SIGAR 19-55 Inspection Report

**Afghanistan's Ghulam Khan Road Project:
Construction of the Road and Bridge Generally
Met Contract Requirements, but Deficiencies
Have Created Safety Hazards for Users**

**AUGUST
2019**

Photo 6 - 30-Inch High Bridge Railing

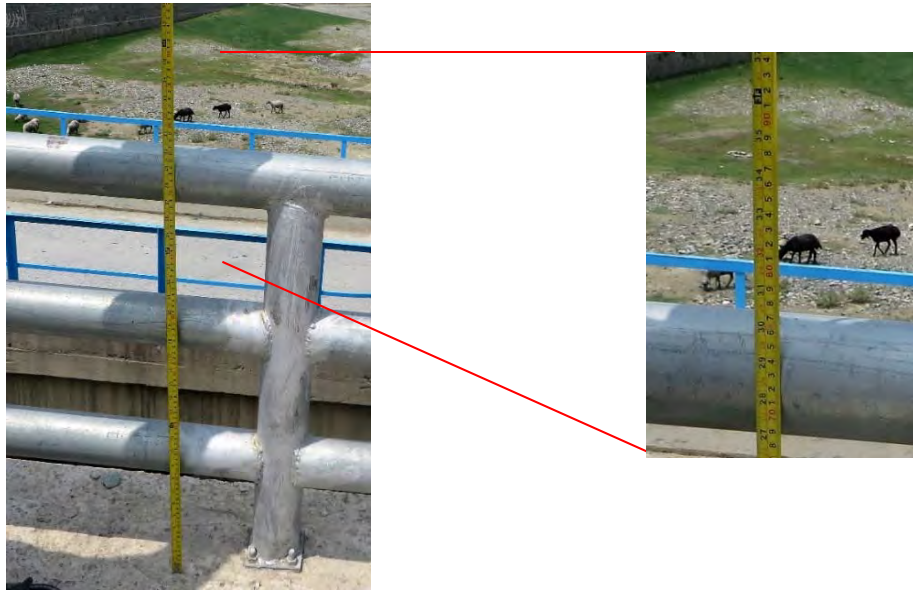
During our July 2018 site visits, we found that BDCI constructed the bridge's pedestrian and cyclist railings, which are bolted on the sidewalk's concrete surface, about 30 inches tall (see photo 6). However, the contract required BDCI to follow the American Association of State Highway and Transportation Officials' standards for bridge design. The standards require pedestrian railings along bridges to be at least 42 inches tall and bicycle railings to be at least 54 inches tall. Although BDCI built the sidewalks on each side of the bridge to accommodate pedestrians and cyclists as required, the low railings create a safety hazard by increasing the risks that they might fall from the bridge.
